SONIC  
RESTAURANT

# STAFF REPORT

RE: **2312 & 2318 N. Roosevelt Blvd  
(permit application # T17-8629)**

An application was received for Final Landscape Plan Approval with Tree Removal. A staff report was created on June 27, 2017 regarding the removal of trees in relation to the development of a commercial business (Sonic Restaurant). The report is attached. On September 27, 2017, a site visit was conducted on the property. The two strangler fig trees are still standing, therefore, the replacement values contained in the report remain valid.

SHEET TITLE:  
**TREE REMOVAL  
PLAN**

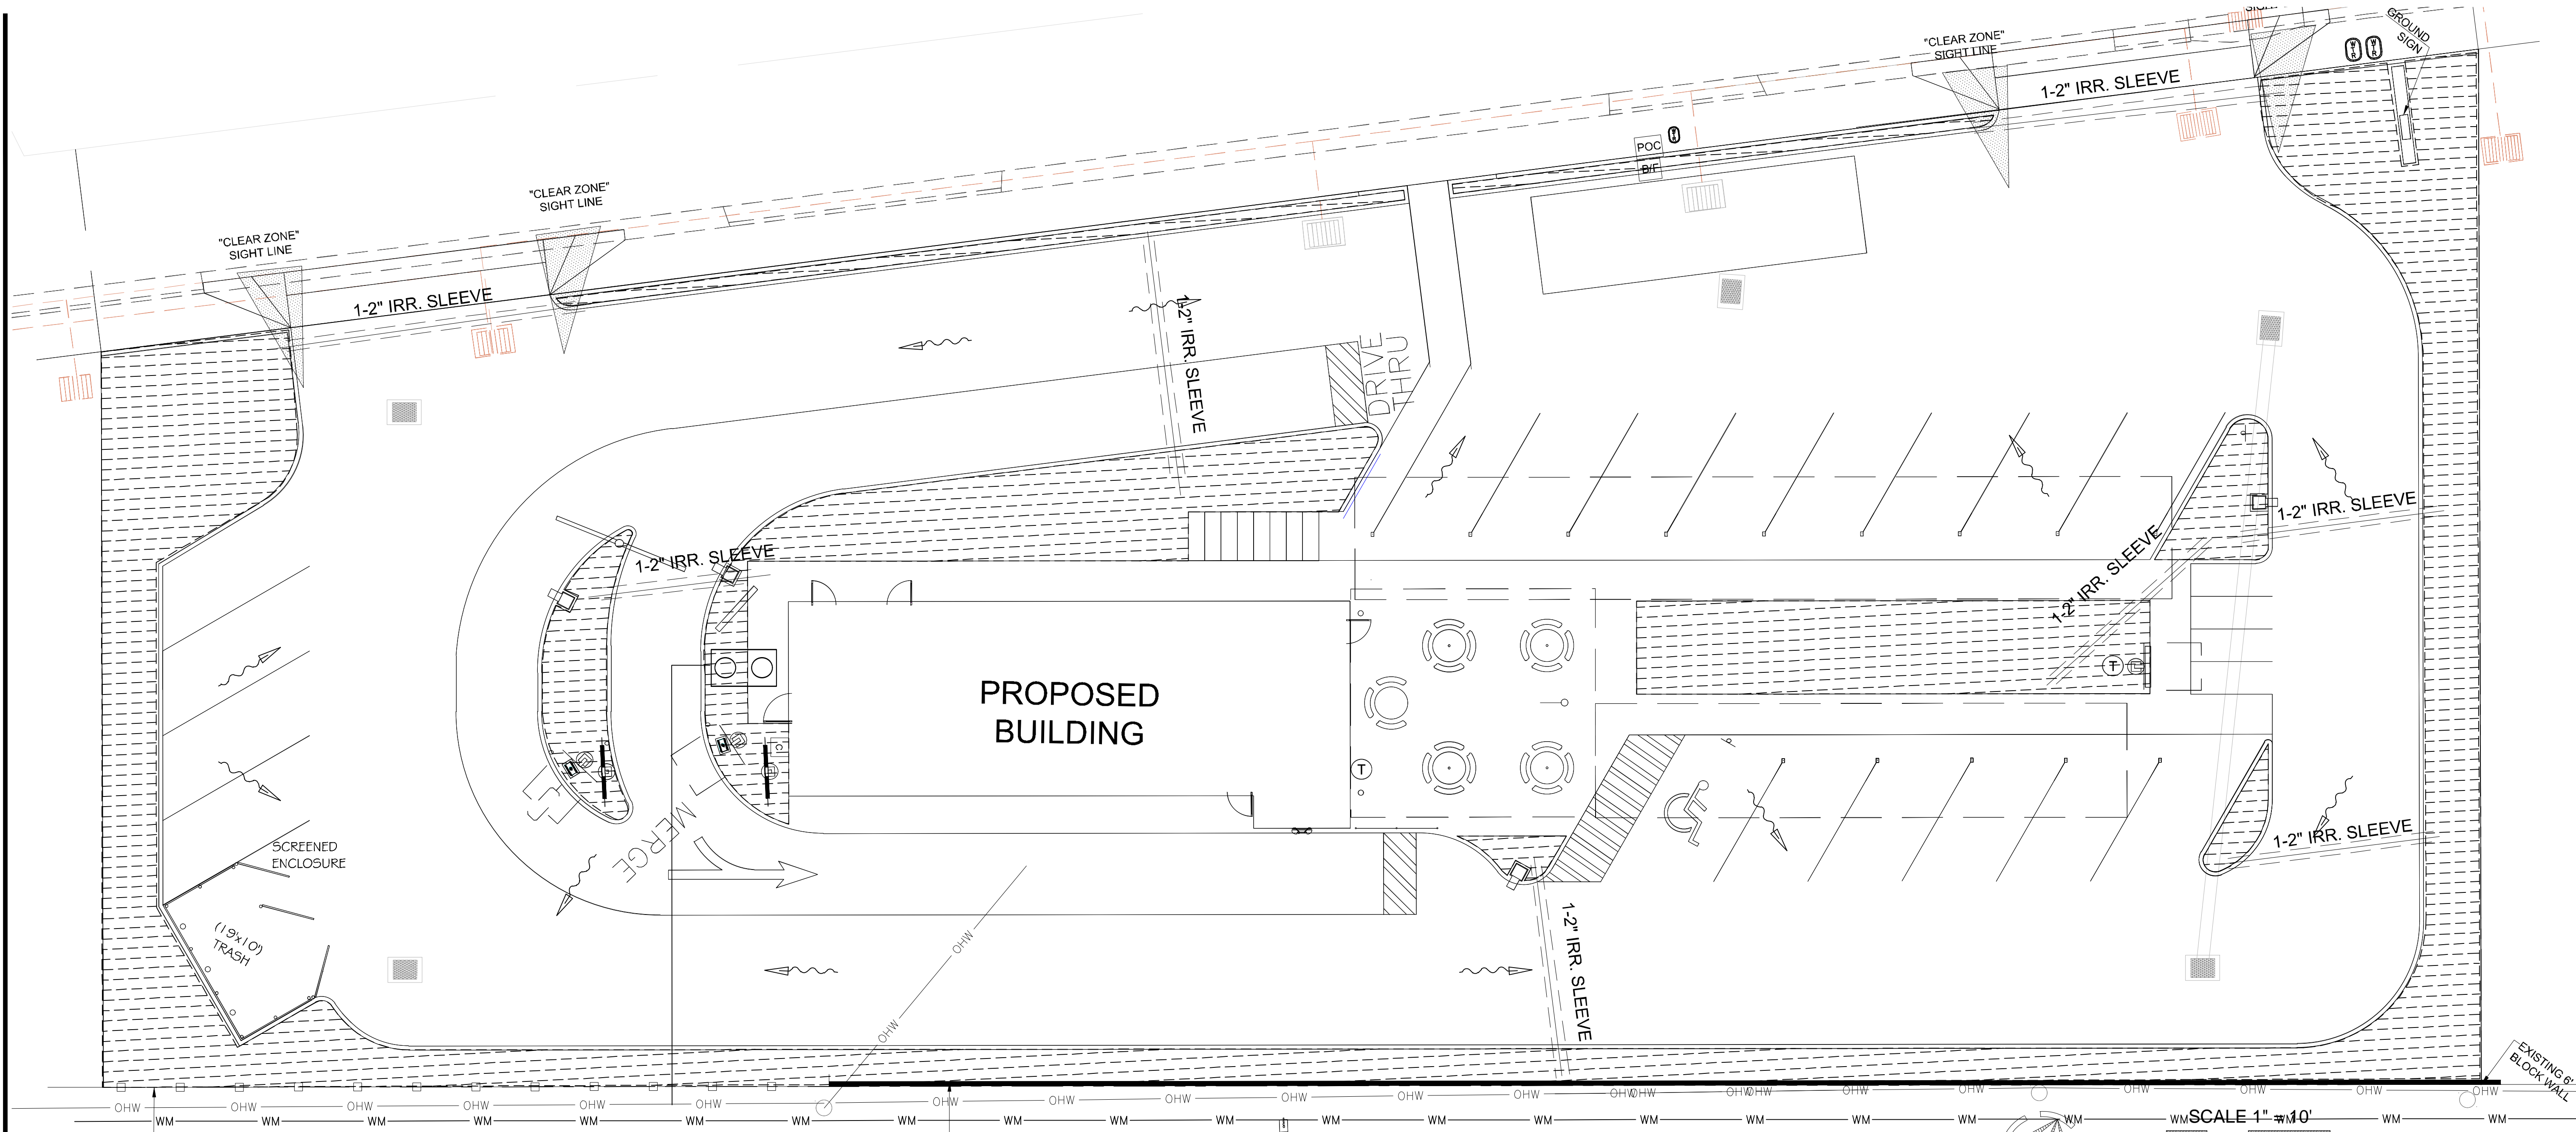
The Final Landscape Plan submitted does incorporate all the required tree removal replacements (46.3 caliper inches) and is over 70% native vegetation.

**Recommendation: Recommend approval of the Final Landscape Plan with Tree Removal to include the removal of (2) Strangler Fig trees at 2318 N. Roosevelt Blvd. The approval requires the replacement of 46.3 caliper inches of native dicot and/or fruit trees from the approved list, FL#1, to be planted onsite and incorporated into the landscape plan.**
